16K Memory for VZ-300 Computer

Notes & Errata

VZ-300 MEMORY EXPANSION
(May 1987, CDI). Pins 2 and 4 of IC4 should be tied low and pins 6 and 15 tied high; not 4 and 15 low, and 2 and 6 high, as indicated. Connecting the circuit as shown may cause damage to either the static RAMS or the VZ-300.

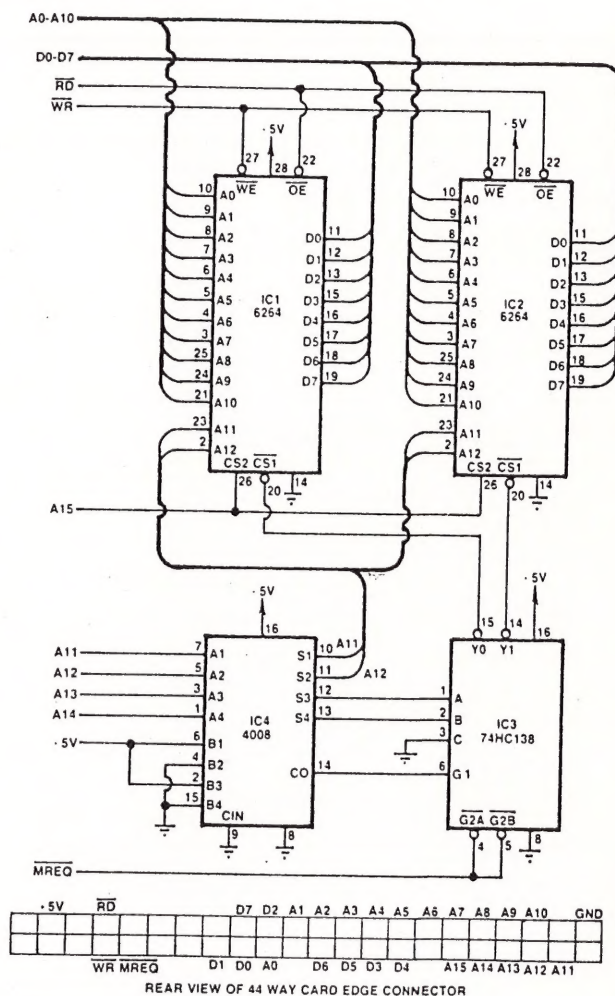
Your Notes & Errata in the August issue say this might happen if the circuit is constructed in the way shown. I have changed the internal RAM chips (4116) but the fault of garbage displayed did not change. I realise that it is not your usual policy but I would be very grateful if you could comment, from advice

you may have received, as to which chip or chips in the circuit are likely to have been damaged by the addition of this expansion. I hope you can help. (W.E.P., Christchurch NZ)

I would like to respond to your reply to W.E.P. ("VZ-300 Expansion Problem", Information Centre, January 1988). I think you may be on the wrong track in your advice.

The "garbage on the display" is a familiar symptom to anyone who has tried to build "add-ons" to system-80s, TRS-80 Model Is etc. I believe the VZ series has similar ROMs.

The problem is that the screen is initially cleared by the startup routine software: there is no hardware clear-screen, and until the startup routine has run, the random contents of video RAM are displayed. Hence the "garbage on the screen".

I have not seen the original circuit, so I don't know exactly what has happened. Things to check are:

(1) Are the ROMs still properly seated in their sockets?

(2) Is there a possibility that there is an address conflict between the new RAM and either the video RAM or the ROM. Perhaps try starting the computer with all RAM removed?

(3) An easy thing to do is to short an address or data line to ground or 5V, or to one of the other bus lines.

In all these cases (and in all cases I have seen) there is usually no "damage" done, no blown chips or anything. You just have to find out why the CPU is not communicating correctly with the ROM & video RAM, remove the faulty connection, and everything works again. (R.L., Downer, ACT)

Some months ago I built a 16k memory expansion for my son's VZ-300, so far I have found it impossible to get to run properly. The fault seems to be incorrect memory addressing.

Could you please tell me if any alterations or corrections were made to the circuit you published. My son is hoping to try and run Stan Blaster, which needs the extra memory, and at present is not pleased with a Dad who can't build things that work. (J.B., Nowra, NSW).

• We haven't had any further advice, but from your description that the unit now displays "garbage", it sounds as if either the 6847 video display controller chip (U15) or the 6116 video RAM (U7) may have been damaged somehow. Or perhaps the 74LS245 bus buffer U14, if there was a bus conflict. A remote possibility is that the Z80A CPU itself has been damaged. Sorry, but it's hard to offer more help than these suggestions.

• Sorry J.B., but items published in the Circuit and Design Ideas section are presented "as is", directly as sent in by readers. As we note each month, we're not in a position to provide any further help with them.
